Re: Application for Site Plan Review and Special Permit  
102 Howe Street, Ashland Landfill  
Response to Peer Review Comments

AMEC Massachusetts, Inc. (AMEC) is pleased to provide the following responses to comments received from the Town of Ashland's consultant, GCG Associates (GCG), in a letter dated February 8, 2016. GCG's comments are included for reference and AMEC's responses follow each comment.

## ASHLAND LANDFILL 907 KW SOLAR PV DEVELOPMENT ASHLAND, MASSACHUSETTS JANUARY, 2016 ISSUED FOR SITE PLAN REVIEW REVISED FEBRUARY, 2016

PROTECT NEWLY TOPSOILED, GRADED AND/OR SEEDED AREAS FROM TRAFFIC AND EROSION. KEEP AREAS FREE OF TRASH AND DEBRIS RESULTING FROM LANDSCAPE CONTRACTOR OPERATIONS.

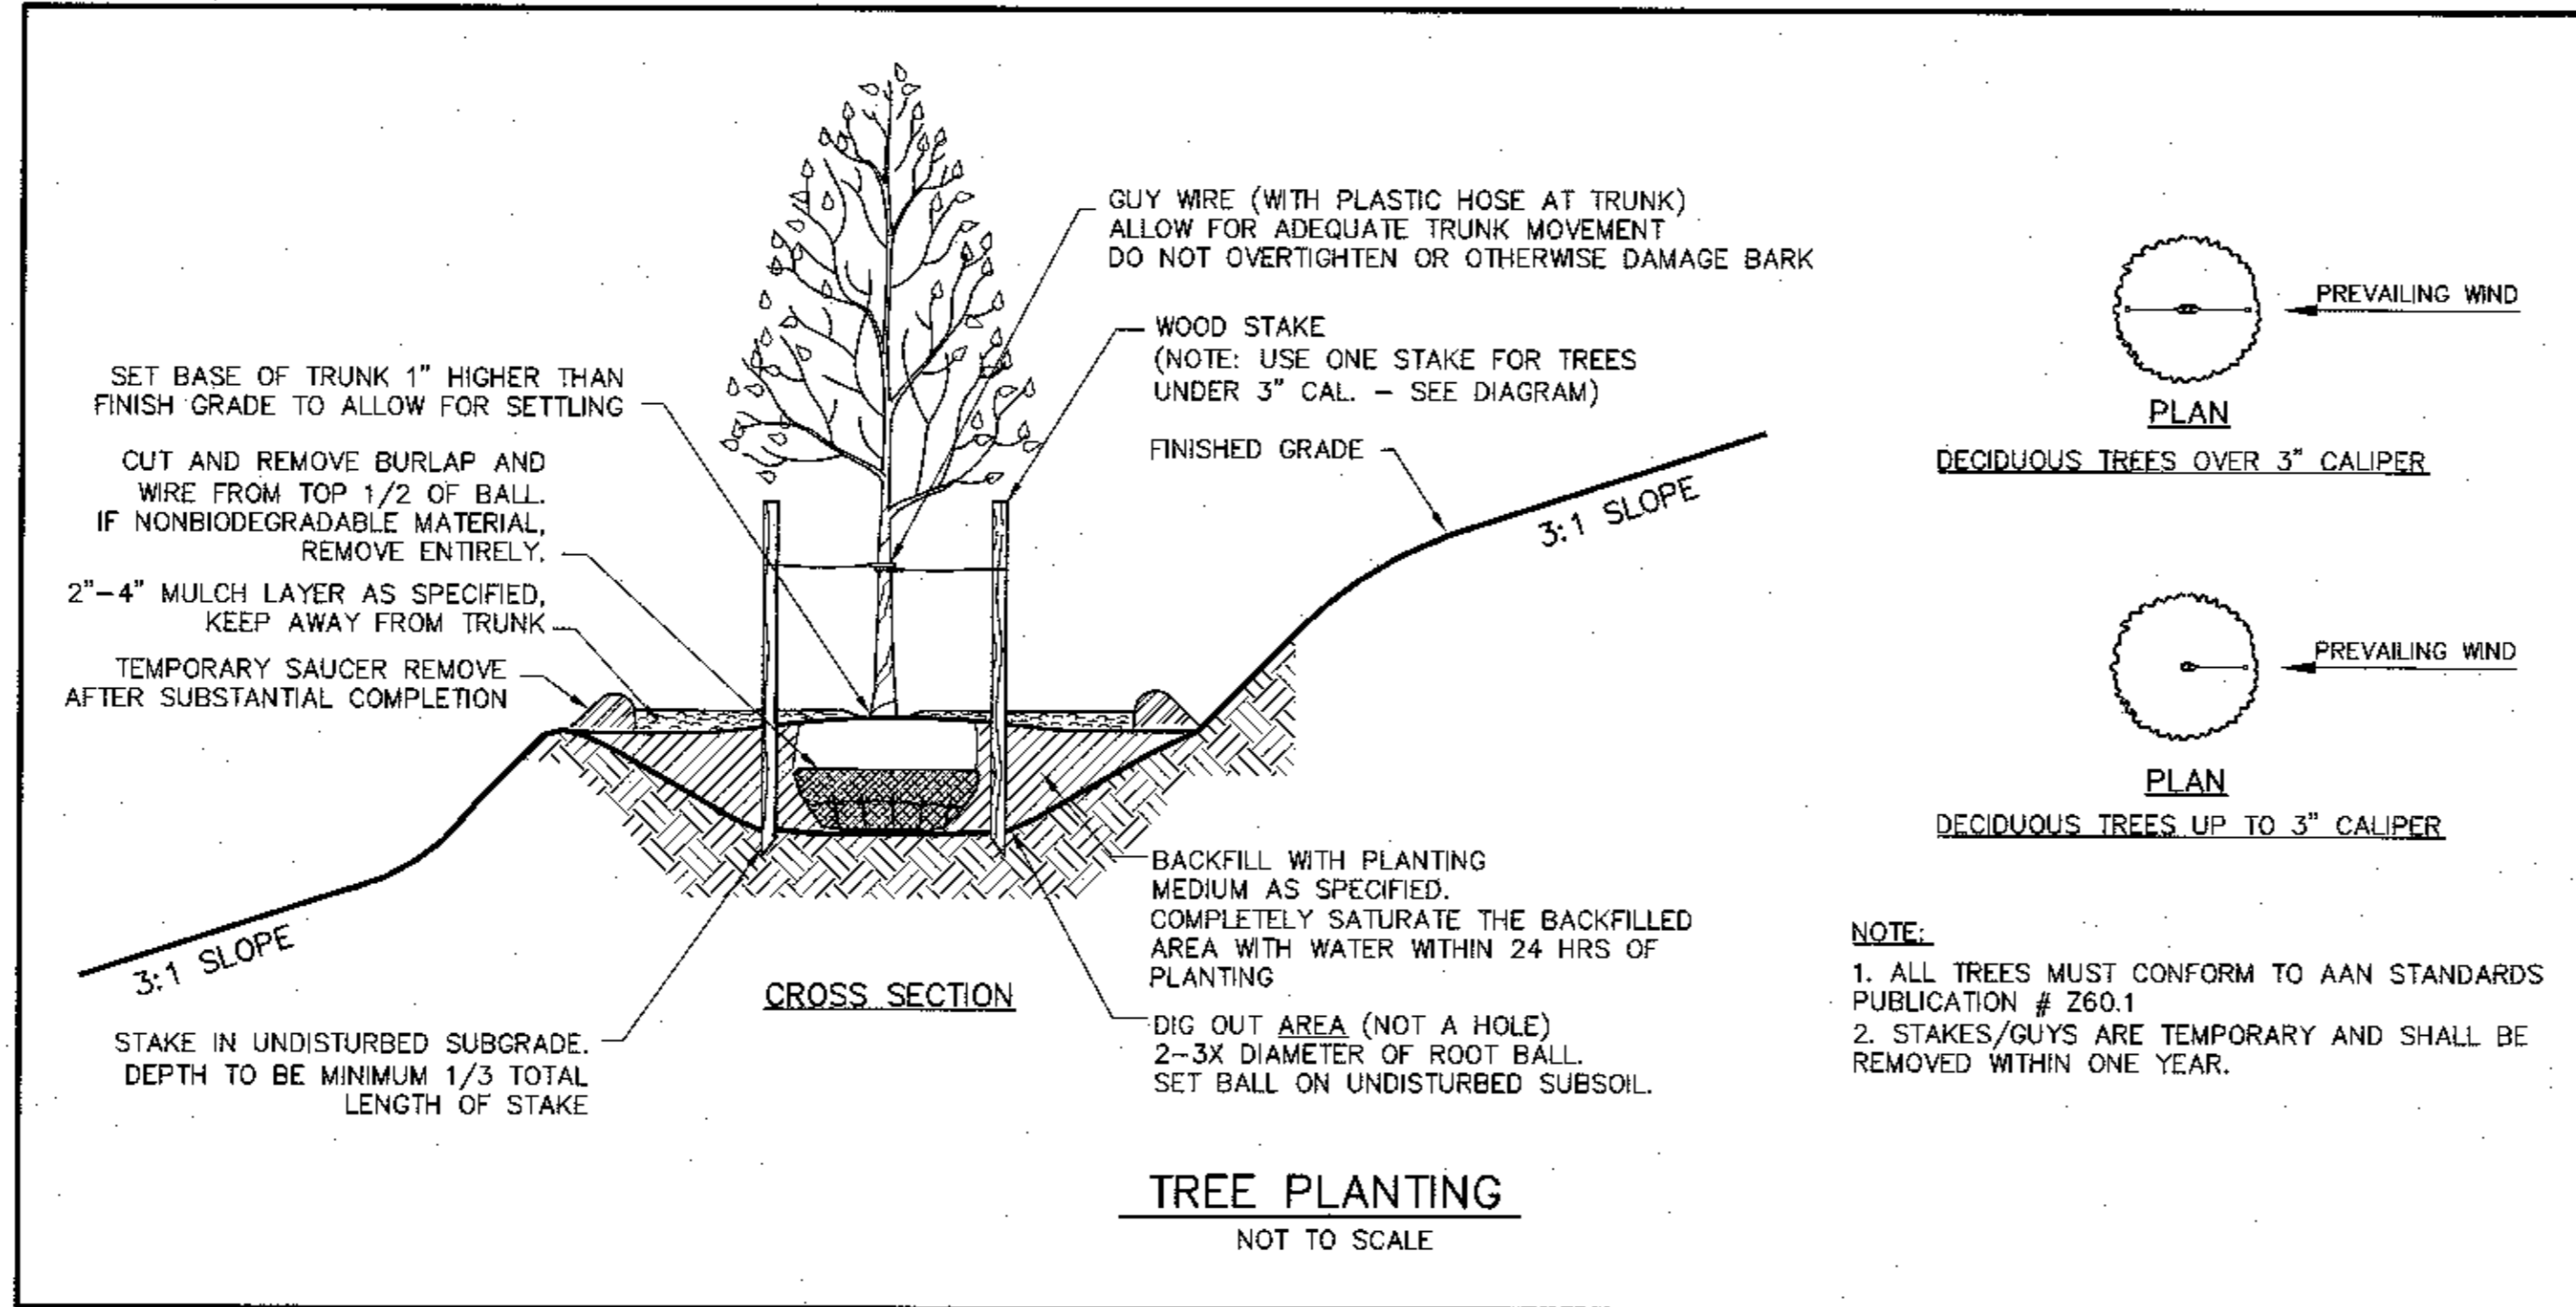
1. Typical Berm Section would require erosion control blanket protection over the 2 horizontal to 1 vertical slope face of the berm. The blanket detail was mentioned on plan sheet 1, but not included on the plan set.

**Engineer's response:** The erosion control blanket detail and notes have been added to Sheet 4. Erosion control blanket is required on all slopes greater than 3:1, therefore it will be installed on the 2:1 slope on the solar array side of the berm. The typical berm section detail on Sheet 6 has also been revised.
